Re: Response to Colorado Geological Survey Review
Soil, Geology, & Geology Hazard Study
Sterling Ranch East – Preliminary Plan No. 1
Parcel Nos. 17, 18, 22, 23, 24, 26, 37, & 38
El Paso County, Colorado
Entech Job No. 220571

CGS COMMENTS AND ENTECH ENGINEERING, INC. RESPONSES

EP-22-0102_1 Sterling Ranch East Phase I PUDSP224

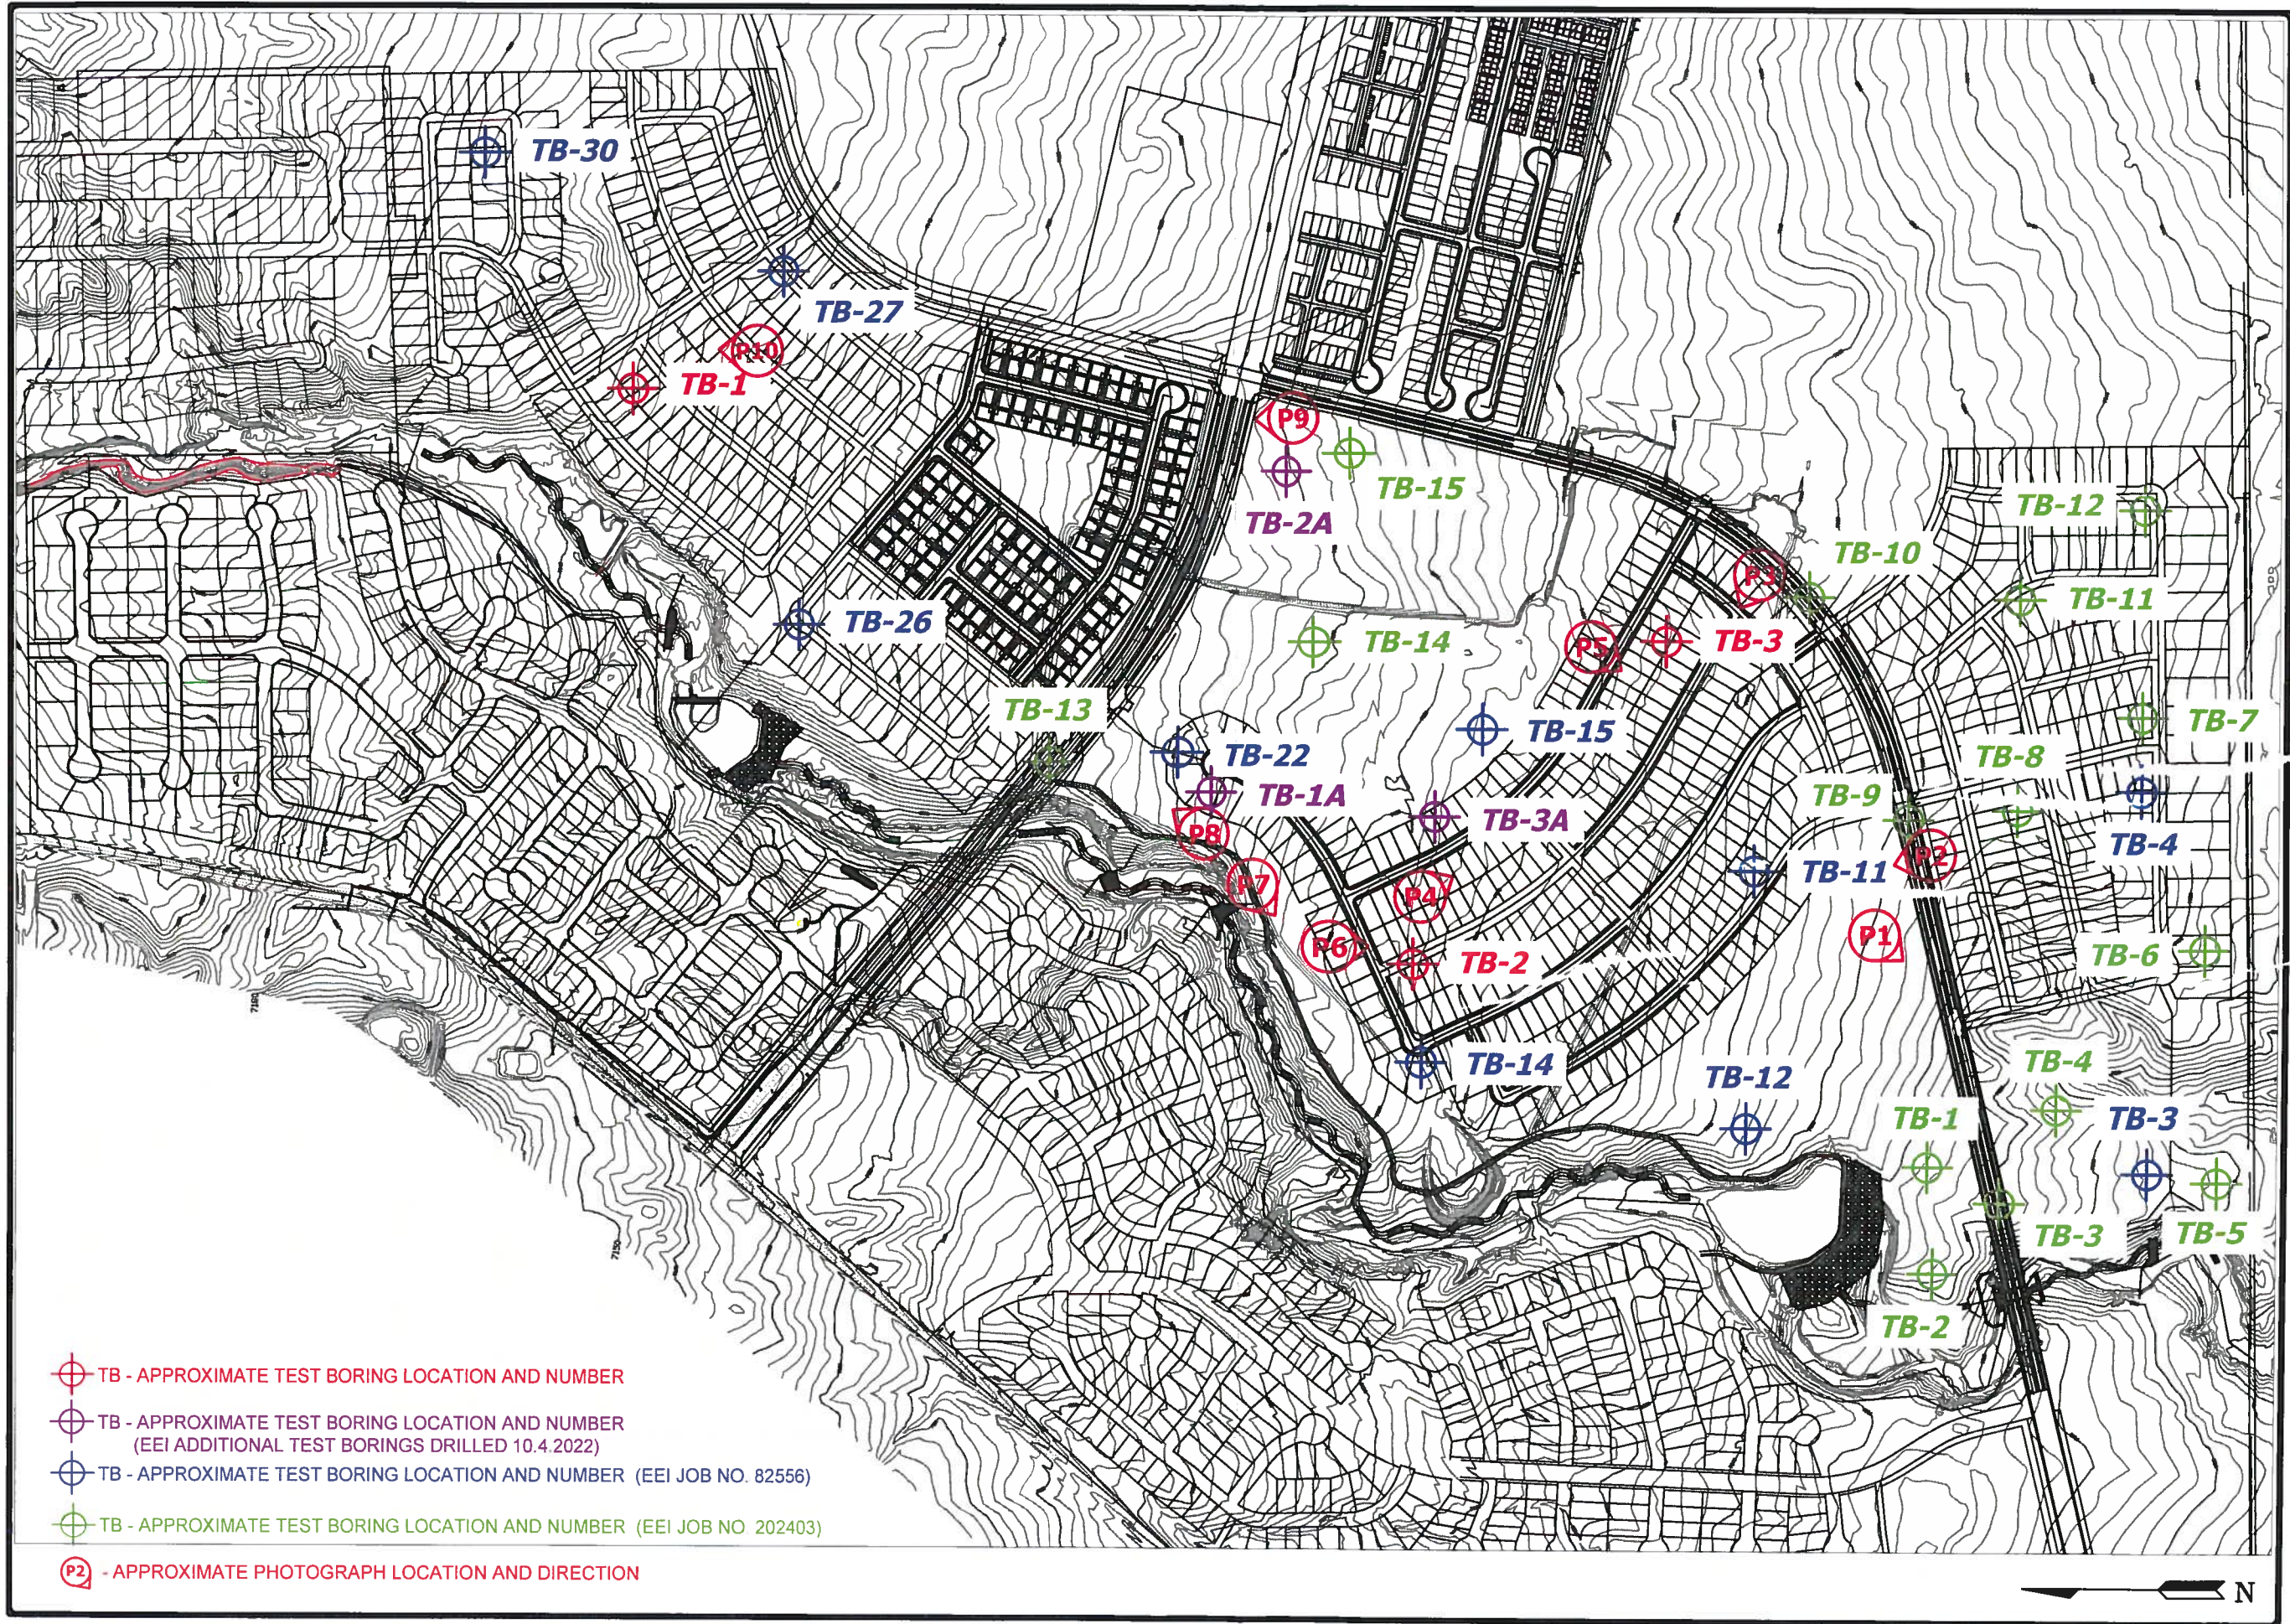
2. In the test borings drilled, groundwater was encountered at 3 to 19 feet below grade during drilling, and Entech observed areas of ponded water in some locations. According to Entech (page 2), "The proposed housing has will (sic) potentially utilize crawlspaces, garden level basements, or full basements." Monitoring/observations of groundwater fluctuations have not been conducted. If basements are planned, **CGS recommends the county require a groundwater monitoring/observation program** prior to the preliminary plan's approval to determine if basements are feasible and if an underdrain system could be employed for this site. To be effective, however, this monitoring should include measurements/observations through fall, winter, and spring and not merely during site-specific building investigations.

We agree with Entech (page 12), "A minimum separation of 3 feet between foundation components and groundwater levels are recommended." Proposed floor levels should be *at least three feet* (preferably five feet) above maximum anticipated groundwater levels and maintained year-round. CGS recommends no below-grade construction in areas with seasonal shallow groundwater levels within three feet of proposed floor levels.
